**Informal meeting on Code of Practice for Packing of Cargo Transport Units
at the request of the United Nations Economic Commission for Europe Working Party on
Intermodal Transport and Logistics**

Geneva and virtual, 29-30 March 2023

Comments to changes to new section 4.2 and Chapter 10

Submitted by the secretariat

Remarks to figure 7.38

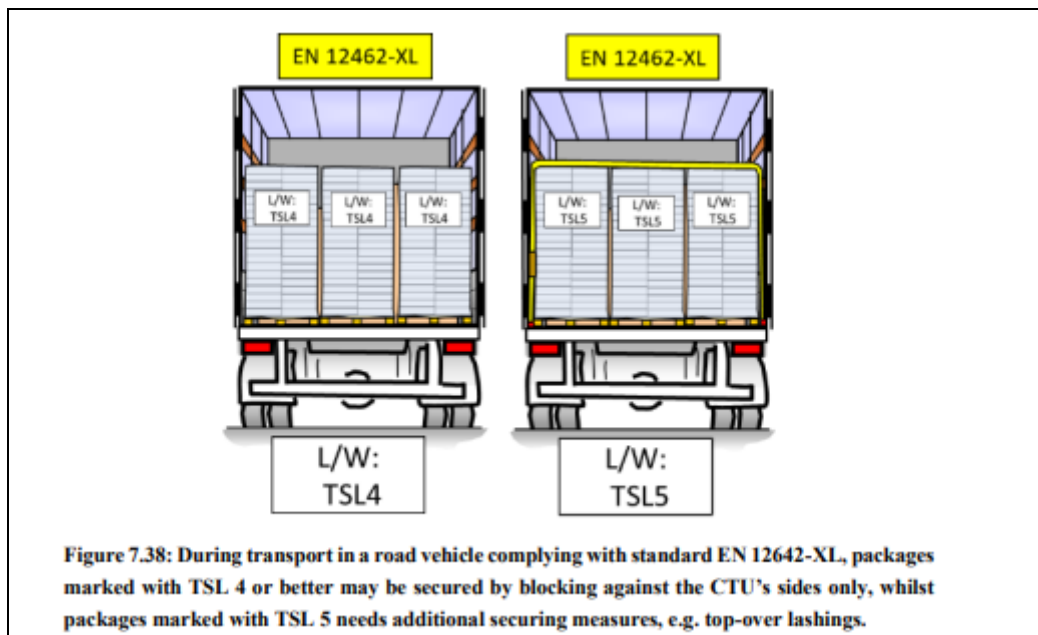
Figure 7.38 and accompanying explanation do not match the table 7.10. The title of both trucks in the figure 7.38 needs to be changed to “EN 12642-L” (instead of “EN 12462-XL”). The explanation should be worded as follows:

“Figure 7.38: During transport in a road vehicle (L-vehicle, curtainsider) complying with standard EN 12642:2016, packages marked with TSL 4 or better may be secured by blocking against the CTU's sides only, whilst packages marked with TSL 5 needs additional securing measures, e.g. top-over lashings.”

Figure 7.6398

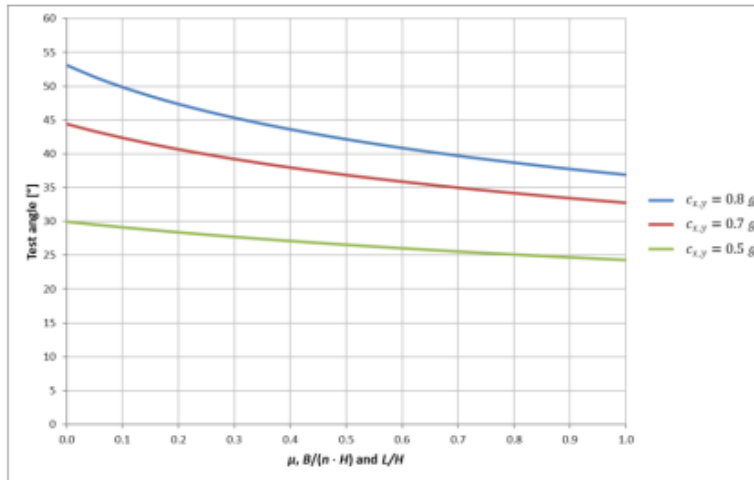
Figure 7.98 and table 7.15 do not contain values for $C_x < 0.5$ and for $C_z < 1.0$. Therefore, this figure and table cannot provide inclination angles for application in longitudinal direction in case of sea transport. As long as no values are provided for inclination angles for application in longitudinal direction at sea, it should be accepted to use the obtained angles from this figure or from this table to carry out the inclination test both in transverse and longitudinal direction.

Therefore, following remark should be included after table 7.15:

“For sea areas A, B and C, it is acceptable to use the obtained angles for cargo securing in transverse direction to carry out the inclination test both in transverse and longitudinal direction.”
